SUBJECT: Top Drive Hydraulic Torque Boost

REFERENCE: ECN #101

PRODUCT BULLETIN 24
FIG. 1

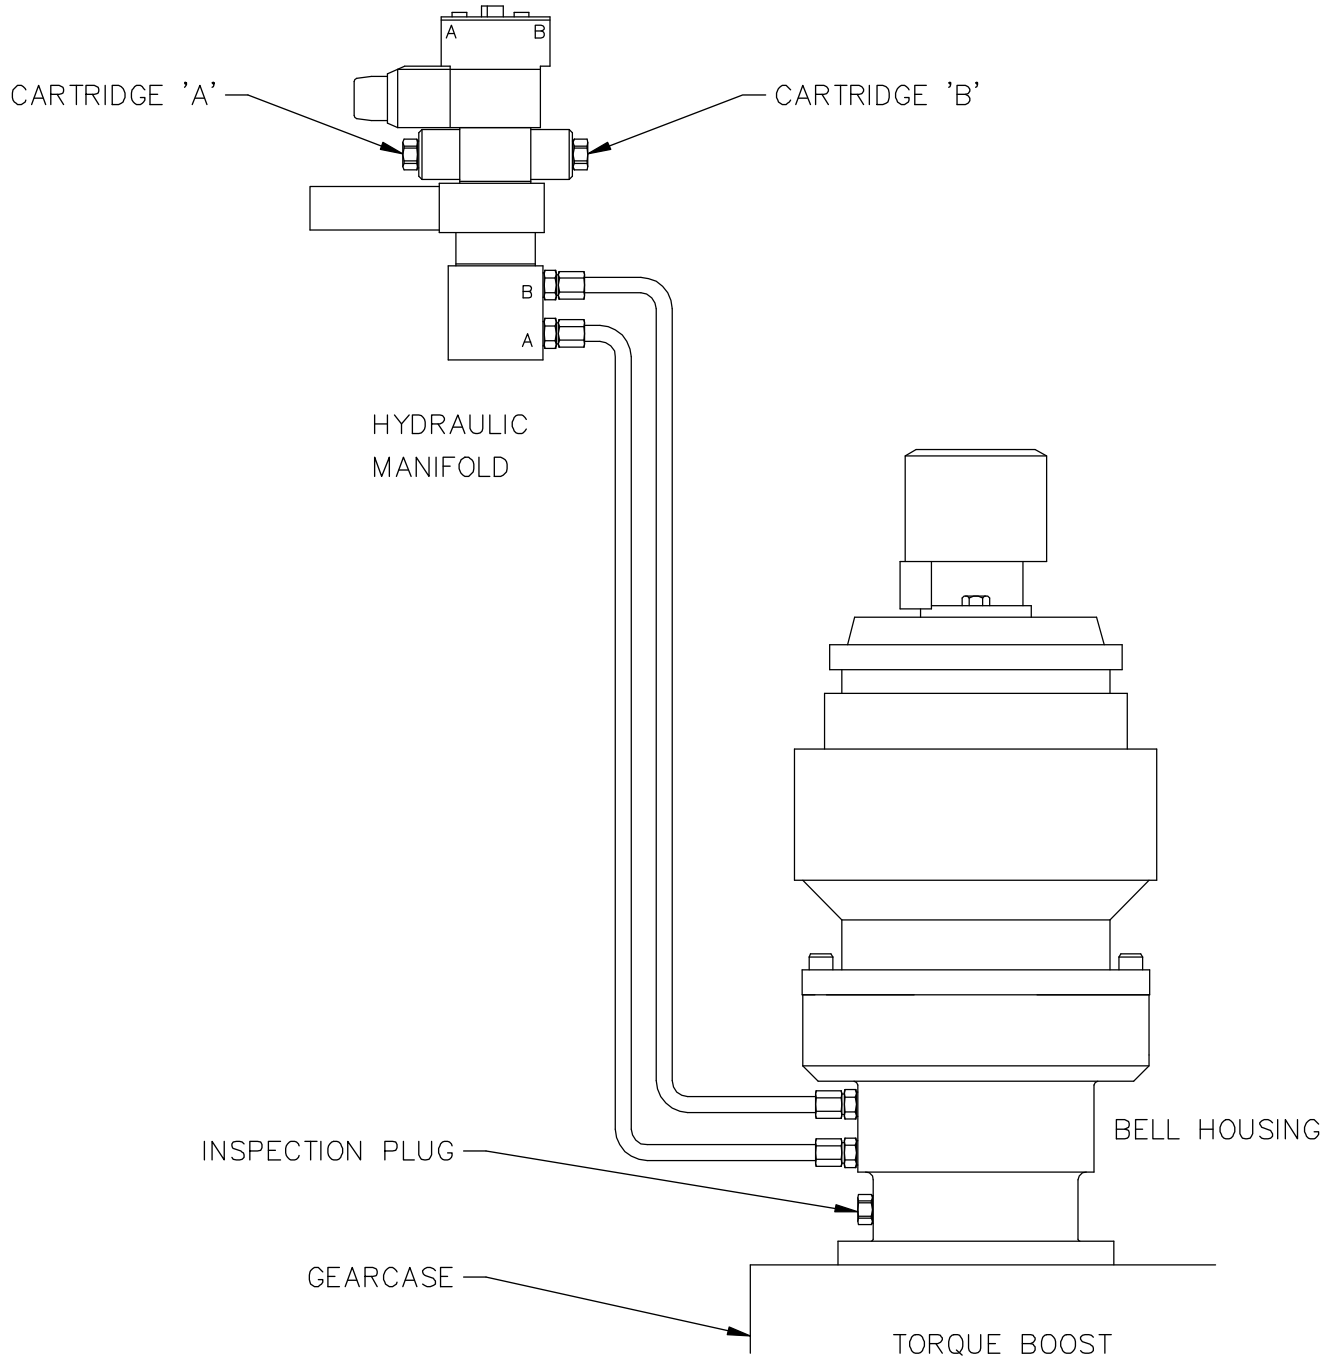
DISCUSSION: Under certain operating conditions it is possible to overstress the bottom torque boost bearing and cause premature failure.

- RECOMMENDATION:**
1. All top drive units with a dual pilot-to-open check valve on the Torque Boost clutch hydraulic valve bank should be changed to a single pilot-to-open check valve on the disengage port of the Torque Boost valve bank. For field modifications, Canrig will supply a plug (part # H13-1026-010) to replace the existing check valve cartridge. Upon receipt of the plug do the following action:
 - a) Confirm that the top drive is plumbed according to Fig.1 attached. The lower port of the valve bank should be connected to the lower port of the torque boost bell housing.
 - b) Remove the check valve cartridge identified as cartridge "B" on Fig. 1.
 - c) Replace with the new plug supplied (part # H13-1026-010).

2. Until the pilot-to-open check valve has been modified avoid using the Torque Boost unless absolutely necessary. If it is absolutely necessary for a connection, and before the modification is completed, use the following procedure:
 - a) Engage the clutch.
 - b) Cycle rapidly between make-up and break-out several times before applying full torque. This will help to ensure full clutch engagement when torquing.

Note: No damage can occur to the torque boost if the clutch is fully engaged. It is only with partial engagement that a chance for damage can occur.
 - c) Engagement can be verified by removing the inspection plug (see Fig. 1) on the torque boost bell housing and visually ensuring proper engagement of the jaw clutch.
